Appendix 6.5:

Further Consultation

Appendix 6.5: Further Consultation

Title: Craigengillan Cairn: Indicative Forestry Proposals	
Source: © Crown copyright and database rights 2019 Ordnance Survey 0100031873	
Client: Infinergy	
Drawn by: TJ	Checked:
Figure: 11.14	
Scale: 1:1000	Revision No: 1

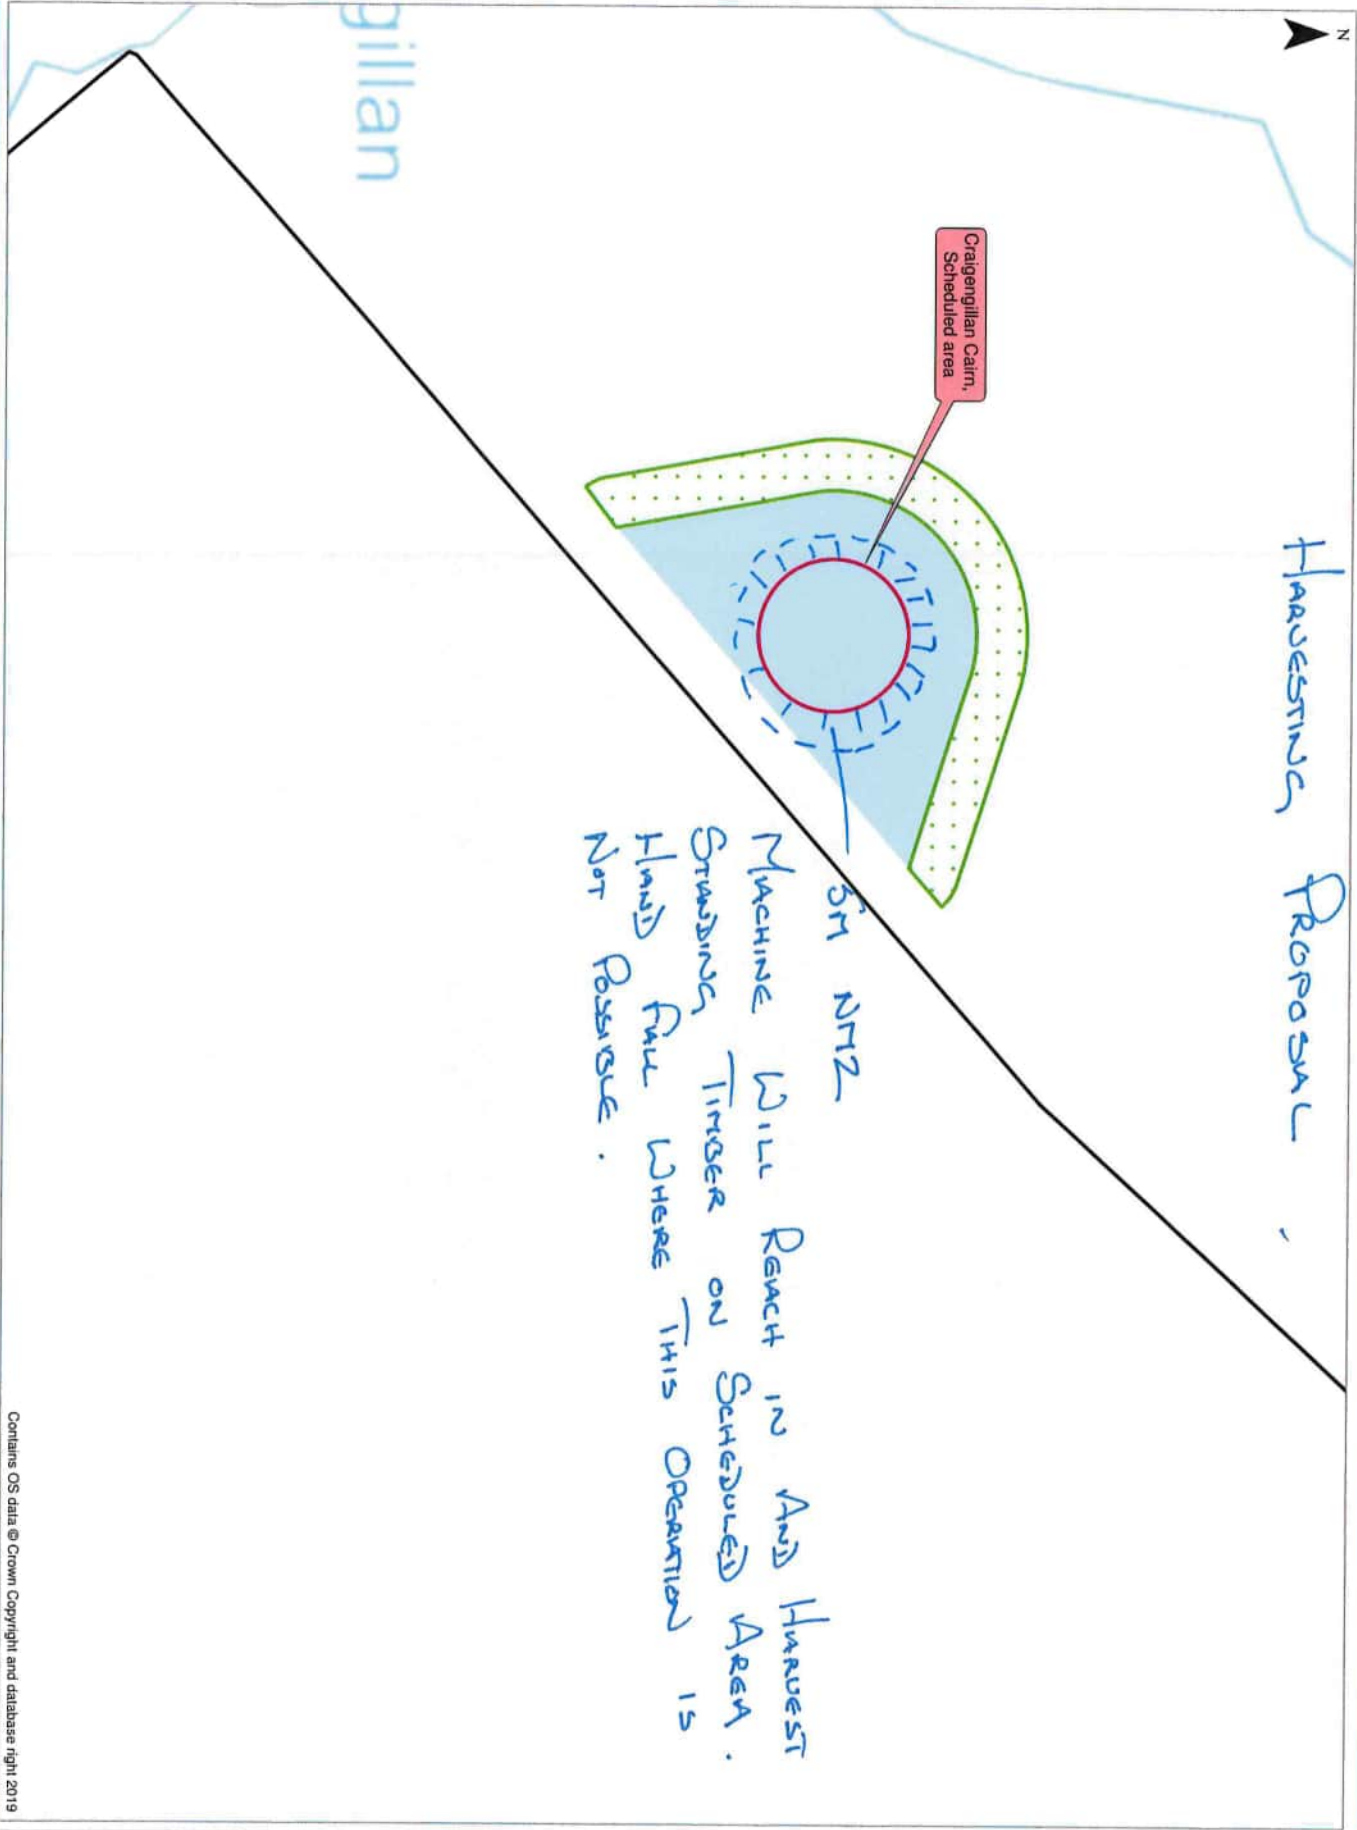
Yes- I see that Infinergy's proposal figure from the AEI has been used as part of the SMC!

Does this mean that you do or don't want the proposals retained for native species to be planted in an arc around the cairn's western side to soften the boundary with the next phase of commercial plantation?

These proposals seem to be retained in the Harvesting Plan/Restock Proposal provided as supporting information for the SMC (albeit I can't see any mention of native trees in any of the application's wording), but IIRC you indicated on our recent Teams call that HES may prefer a wider tree-less buffer than the band of the native trees.

We have an opportunity to amend these proposals as part of the Proposed Varied Development. Just let me know.

Figure 12.1: Noise Assessment and Wind Turbine Locations

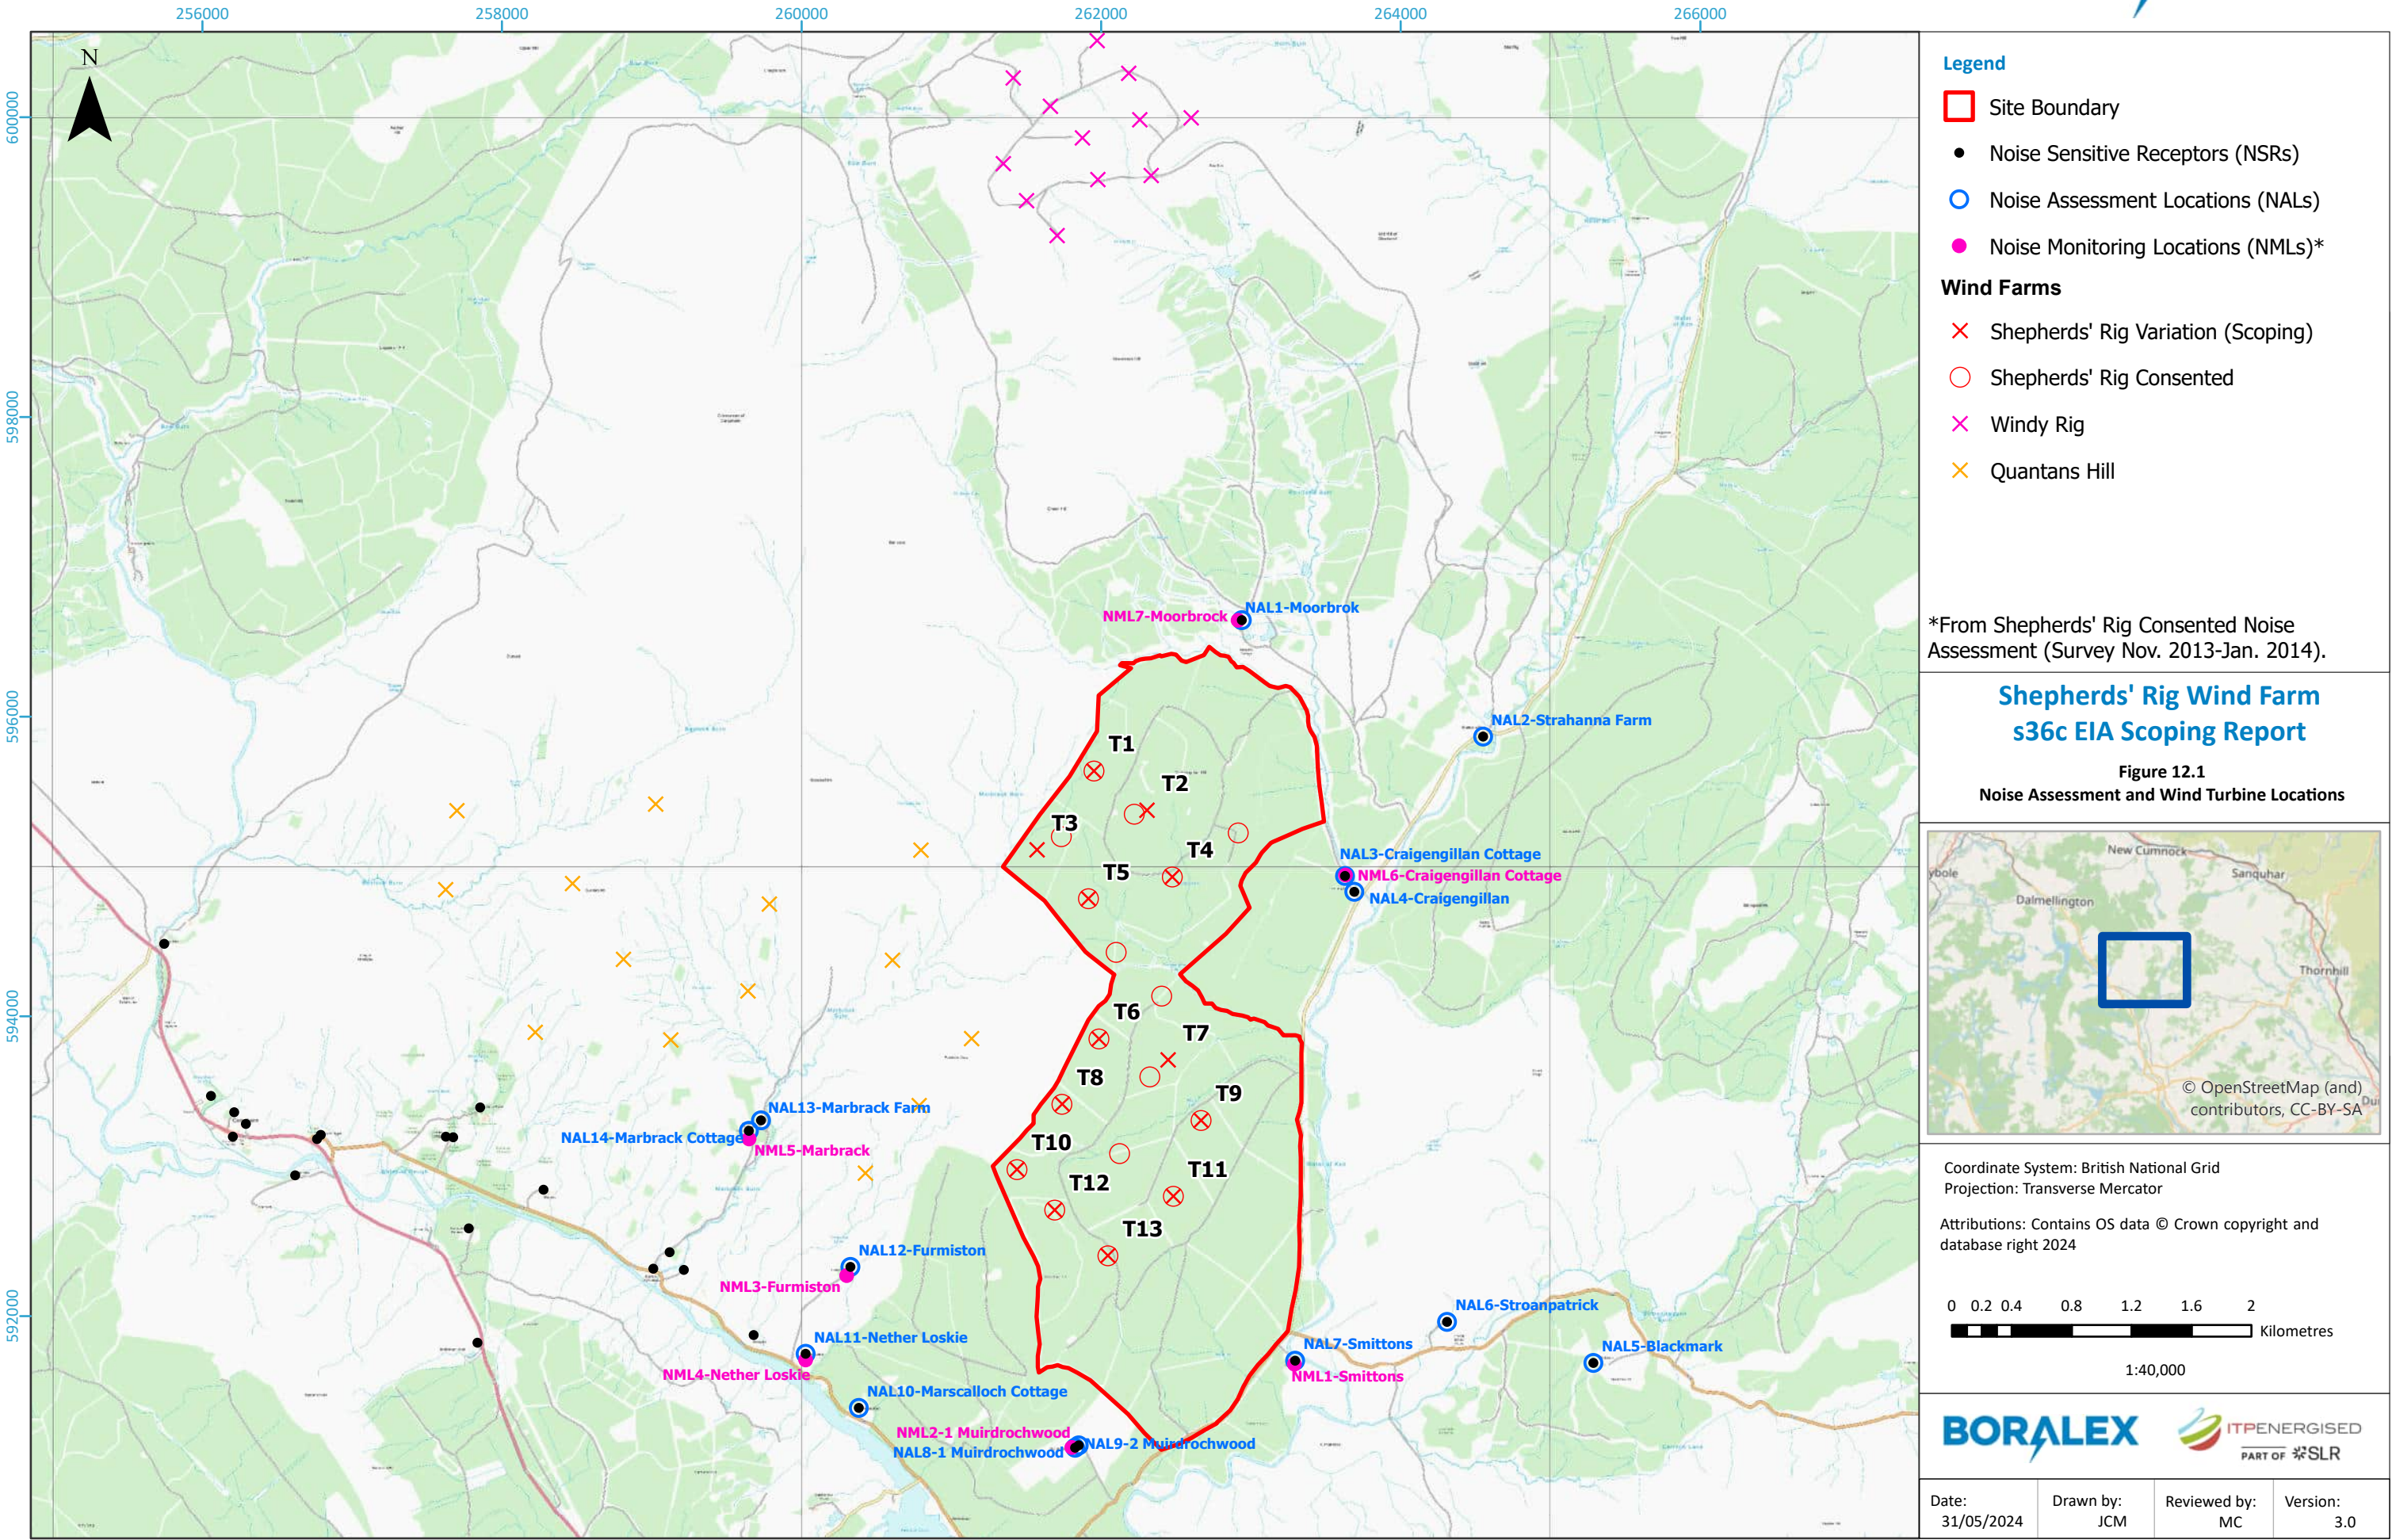
Figure 12.1 from the Scoping Report (of which a copy is enclosed at end of this letter) shows all identified receptors surrounding the Proposed Varied Development; proposed Quantans Hill Wind Farm and operational Windy Rig Wind Farm. The figure also shows receptors suggested for a detailed assessment, and these are labelled Noise Assessment Locations (NALs). These NALs will be assessed based on new noise predictions and the same ETSU-R-97 fixed minimum criteria to calculate Total Noise Limits (also called cumulative noise limits) as Environmental Health had agreed in March 2021 for Quantans Hill (as documented in the Quantans Hill Environmental Impact Assessment (EIA) Report noise chapter). The Total Noise Limits and fixed minimum criteria we will use can be summarised as follows:

The background noise levels of reference to use are those from the Consented Development's noise survey of which the Noise Monitoring Locations are shown in Figure 12.1 enclosed.

Figure: s36C Scoping Layout

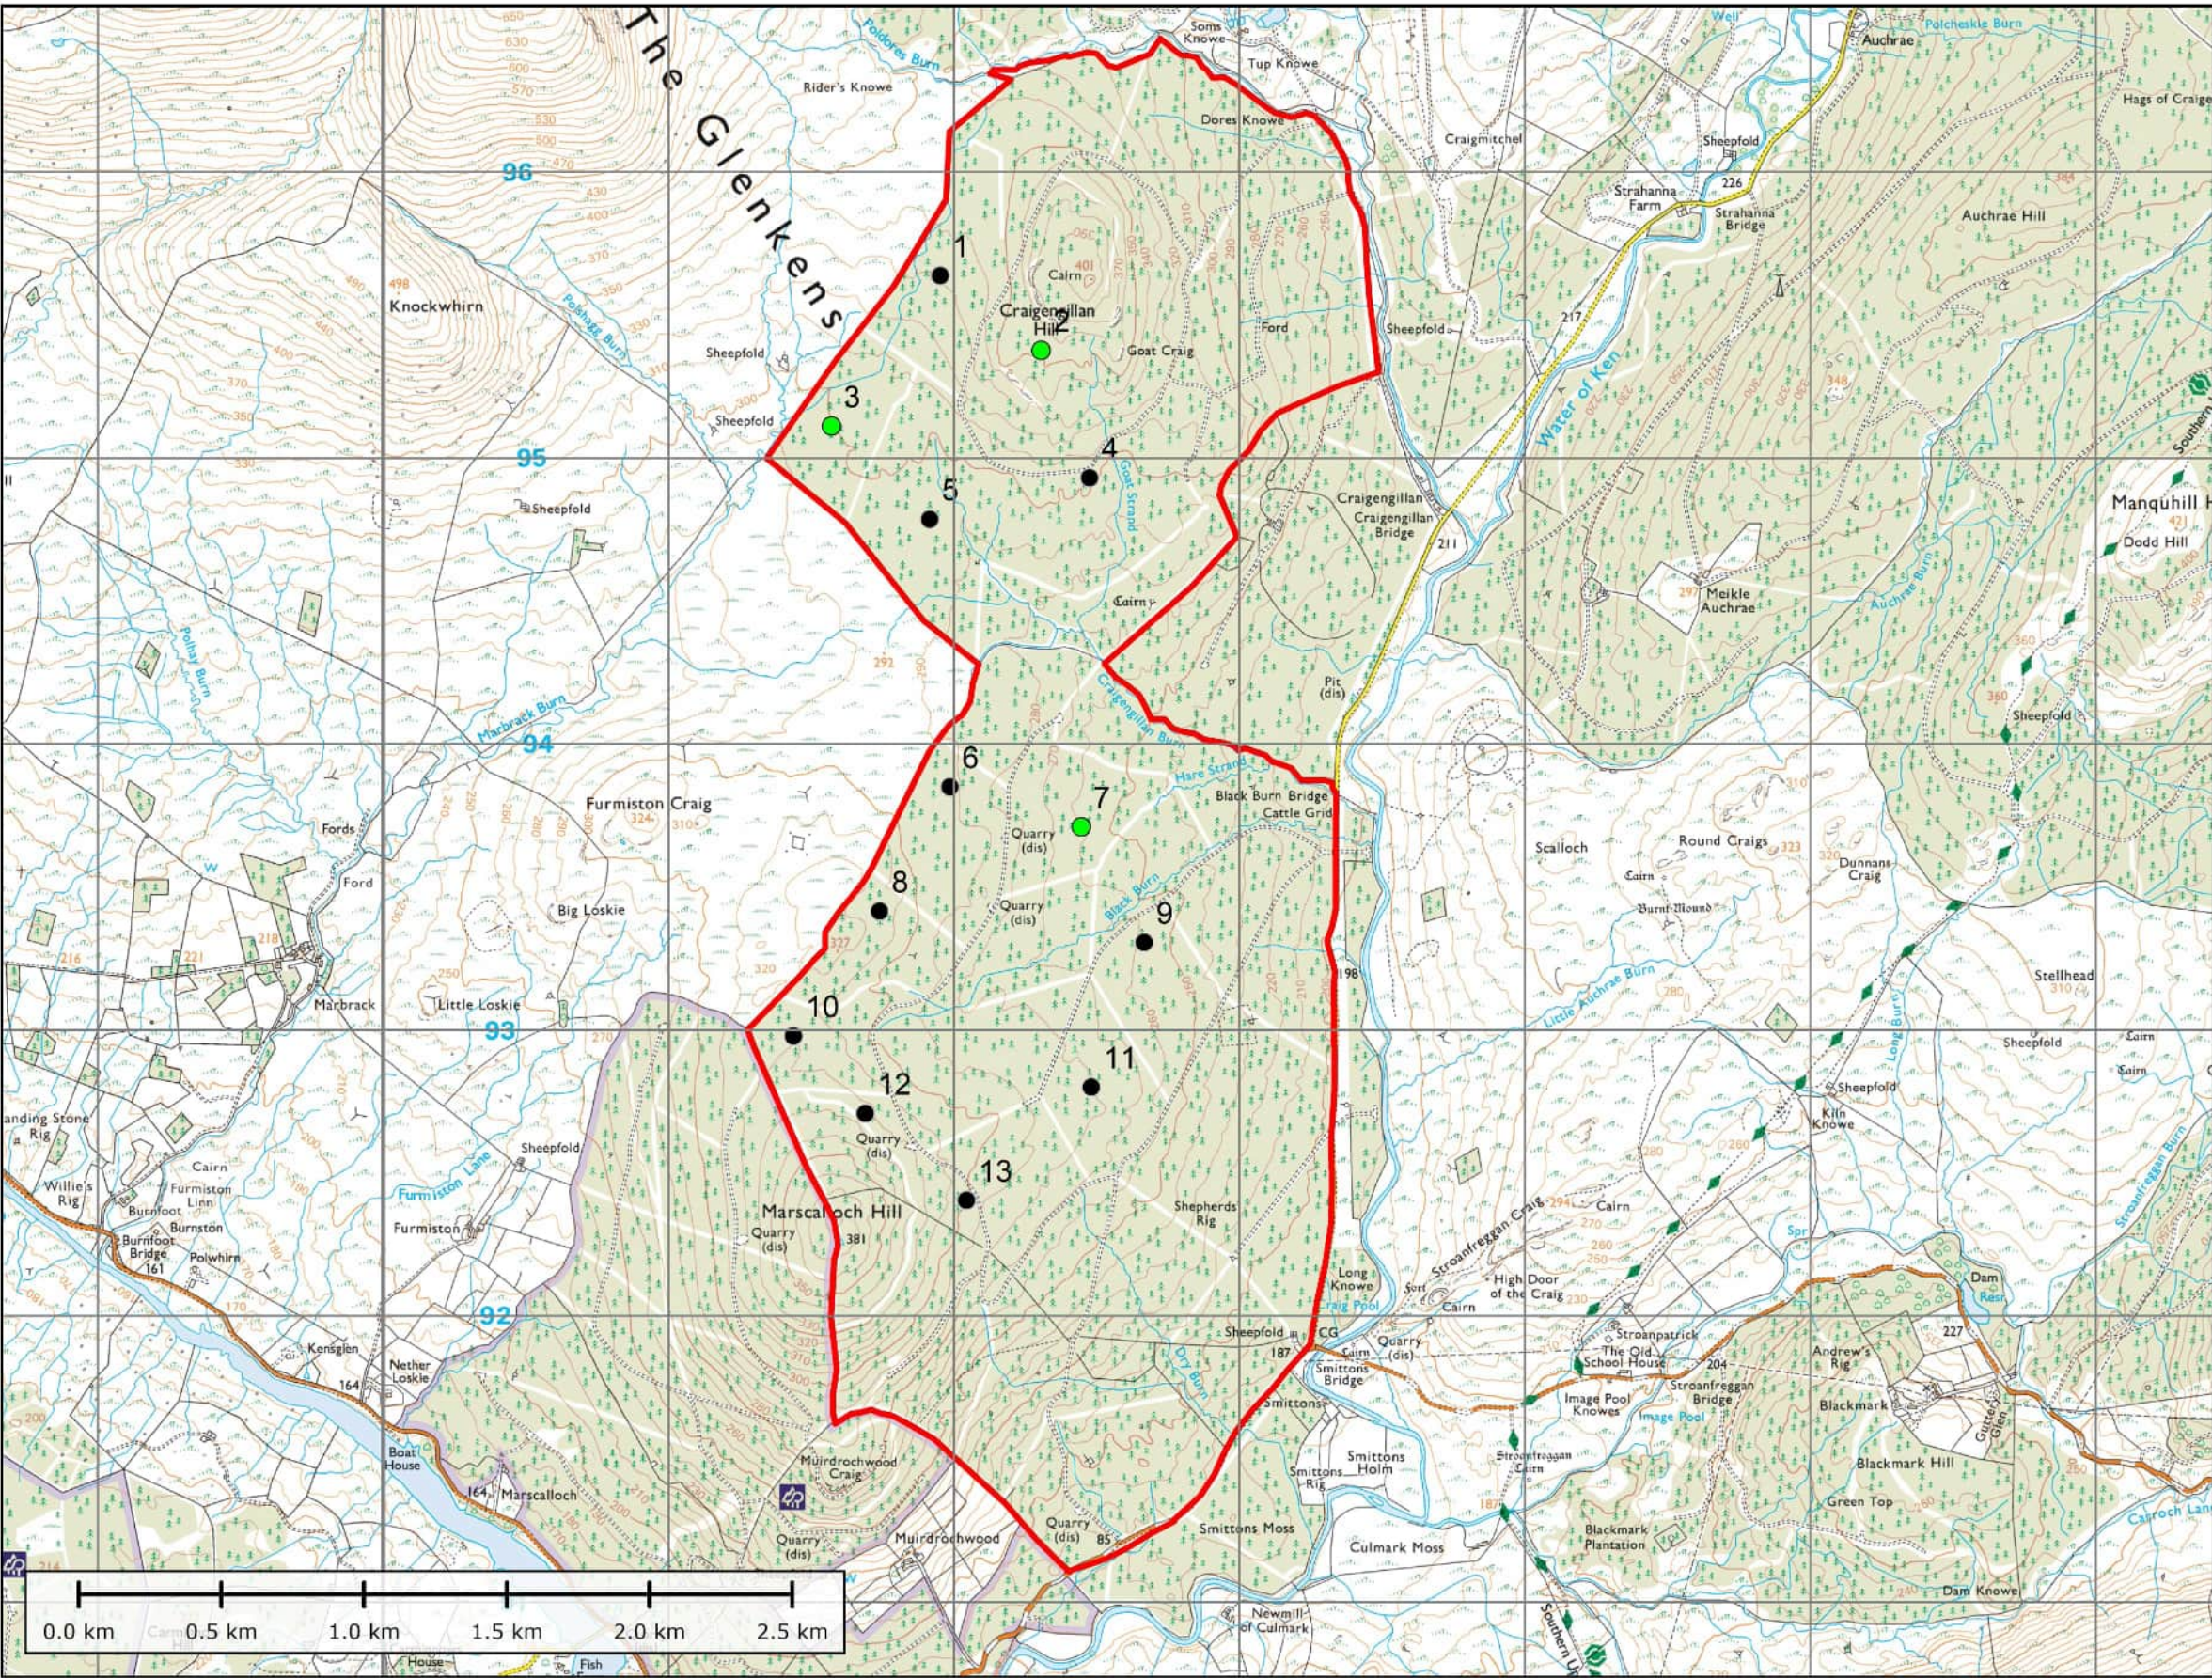
We are concerned that turbine 4 (as shown on the Proposed Varied Development Layout Figure) could have a significant impact on views to the north from the cairn, and views of the cairn from the east and southeast. Photomontages of views from the cairn, and towards the cairn with the development behind, would be required for us to be able to properly assess the impact of the increased size of this turbine.

For views to the south and west of the cairn, the revised proposals would be an improvement on the previous layout. In particular, the removal of the turbines 8 and 9 (from the previous layout numbering as shown on Cultural Heritage Viewpoints - Comparative Wirelines) would open up views and reduce the negative impact on the setting of the monument.
